# Access Compliance Report

## Public Rights-of-Way

### (Curb Ramps)

Intersection ID: 2739	Main Street: BELL'S_MILL_DR	Cross Street: WINGMONT_DR	Location: SE
ADA ID: 0FC8F5ABD513	Ramp Type: PerpDiag	Initial Pass/Fail: Fail	Overall Compliance: No
		Severity Score: 12.5

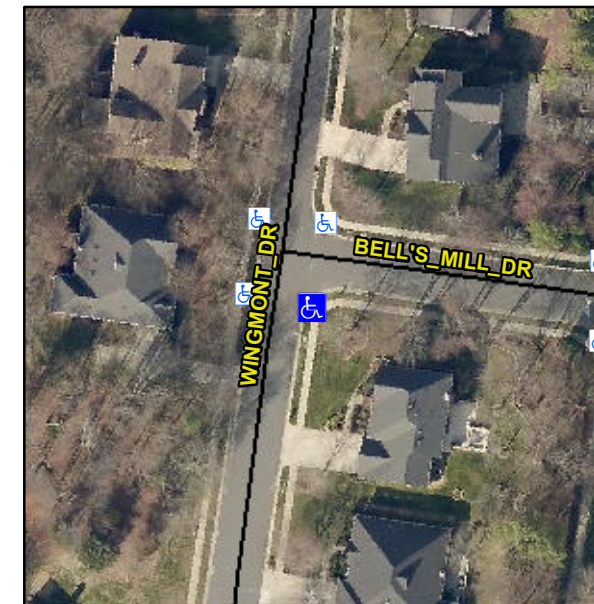
**Not Found, R304.2.2**

Compliance	Description	Data	Compliance	Description	Data
N/A	Ramp Length (in)	47.0	No	Ramp Slope (%)	10.6
Yes	Ramp Width (in)	53.5	Yes	Ramp XSlope (%)	1.4
N/A	Flare Type LT	N/A	N/A	Flare Type RT	N/A
N/A	Flare Slope LT (%)	N/A	N/A	Flare Slope RT (%)	N/A
N/A	Flare Traversable LT?	N/A	N/A	Flare Traversable RT?	N/A
N/A	Landing Length (in)	N/A	N/A	DWS Provided?	N/A
N/A	Landing Width (in)	N/A	N/A	DWS Contrast?	N/A
N/A	Landing Slope (%)	N/A	N/A	DWS Length (in)	N/A
N/A	Landing X Slope (%)	N/A	N/A	DWS Full Width?	N/A
N/A	Landing Curb? (Y/N)	N/A	N/A	DWS Offset (in)	N/A
N/A	Shared Landing?	N/A			
N/A	Gutter Ponding?	N/A	N/A	Gutter Slope (%)	N/A
N/A	Gutter Lip Ht (in)	N/A	N/A	Gutter X Slope (%)	N/A
N/A	Painted X Walk1?	No	N/A	Painted X Walk2?	No
	X Walk 1 Direction	To N		X Walk 2 Direction	To W
N/A	X Walk 1 Width (in)	N/A	N/A	X Walk 2 Width (in)	N/A
	X Walk 1 Slope (%)	0.9		X Walk 2 Slope (%)	2.8
	X Walk 1 X Slope (%)	1.1		X Walk 2 X Slope (%)	0.9

**Remove & Replace Curb Ramp With Two New Directional Ramps or Equivalent.**
